ALEXANDRIA AIRCRAFT LLC
Alexandria MN 56308

SERVICE LETTER B-110

May 8, 2007

SUBJECT: EXHAUST SYSTEM INSPECTION AND REROUTING MAGNETO "P" LEADS

Figure 1: Typical Exhaust System
(Left side Looking Inboard)

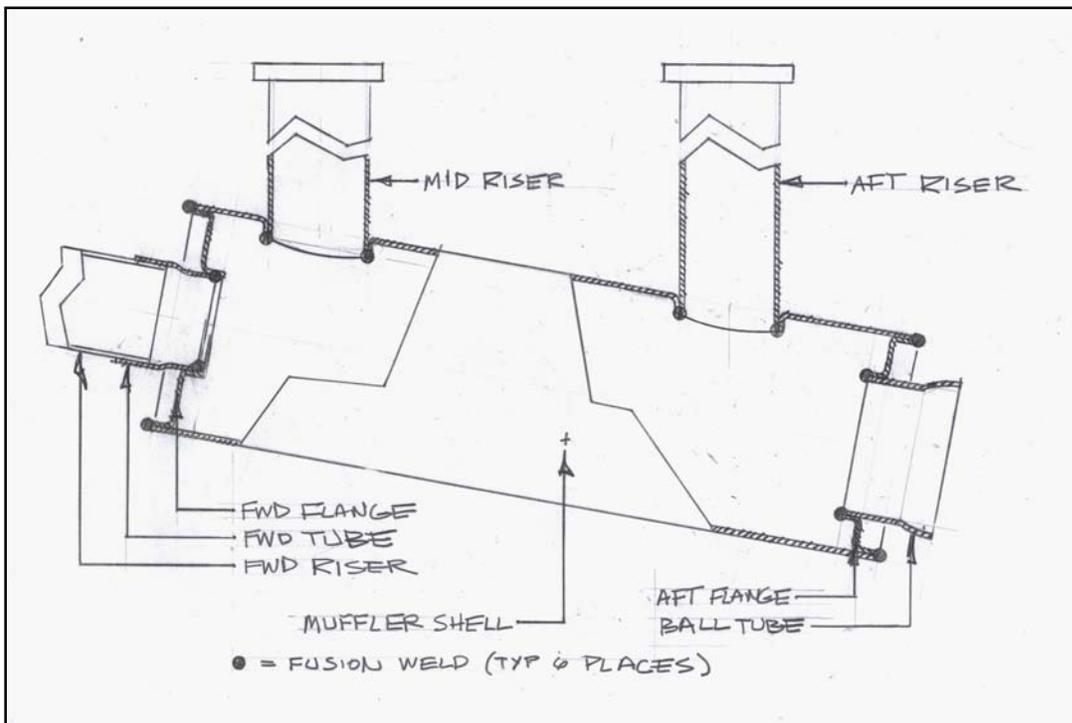
A typical exhaust system is illustrated in Figure 1. The figure has two cut-outs (one forward, one aft) each showing cross-sections thru the muffler assembly centerline. The figure is not drawn to scale and does not include the shroud for the cabin heat exchanger nor the external flange which supports same. The fusion welds to be inspected are shown as small black spots where the weld would be located on the cross-section; the actual welds go all around the tube. Thus, there are six welds which are considered critical and must be inspected. Two external welds join the Muffler Shell to the Forward and Aft Flanges. Four internal welds join: 1) the Forward Tube to the Forward Riser, 2) the Muffler Shell to the Middle and Aft Risers, and 3) the Aft Flange to the Ball Tube. Note - the Forward Riser slip-fits into the Forward Tube.

The welds, tubes, and flanges must be inspected closely all the way around same welds, tubes, and flanges. Any exhaust deposits and/or corrosion should be removed to facilitate the inspection. If there is any visible abnormality which suggests that a crack is present, follow the visual inspection with a more detailed inspection such as a dye-penetrant inspection or remove the muffler in its entirety and pressure-test the muffler using soap bubbles to detect a leak/crack. The muffler fails the inspection and is considered defective and unusable if any cracks or other defects such as excessive wear are found. The inspection will be accomplished to the following procedure.

1. Remove the heat exchanger shroud.
2. Visually examine the two external welds which connect the Muffler Shell to the Forward and Aft Flange's. Look at the weld itself and where the weld ends. Visually examine the Forward and Aft Flanges for cracks, taking special notice at the flange radius.

3. Visually examine the slip-fit joint between the Forward Riser and the Forward Tube for wear and/or cracks in same parts; remove the Forward Riser if necessary.

4. Disconnect and remove the tail pipe assembly.
5. Use a light and inspection mirror to look into the muffler thru the inside of the Ball Tube and examine the internal welds which attach the Forward Flange to the Forward Tube and Aft Flange to the Ball Tube for cracks. Look at the welds themselves and where they end. Visually examine the interior surfaces of the Forward and Aft Flanges for cracks, taking special notice at the flange radius.

6. Use a light and inspection mirror to look into the muffler thru the inside of the Ball Tube and examine the internal welds which attach the Middle and Aft Risers to the Muffler Shell for cracks. Look at the welds themselves and where they end. Visually examine the interior surfaces of the Riser Tubes for cracks. Visually examine the radius of the Muffler Shell adjacent to the weld for cracks.

Some mufflers have internal diffusers which are not shown in the figure. Check the condition of the diffuser. If it is deteriorated, part or all of it may dislodge and restrict the exhaust flow. If the diffuser prevents inspection of all internal welds, remove the muffler in its entirety and pressure-test the muffler using soap bubbles to detect any cracks.

Mufflers in Model 17-30A SN 30906 and up have a slip joint for the middle riser tube which is not shown in the figure. The slip tube has an internal weld which must be inspected along with the slip-joint.

If any cracks or other defects are found, the muffler and tailpipe assemblies must be replaced/repared according to the requirements of Section 5: REPLACING/REPAIRING EXHAUST SYSTEM PARTS. If no cracks or other defects are found, the muffler and tailpipe assemblies may be reassembled according to Section 6: REASSEMBLY IF NO CRACKS ARE FOUND.
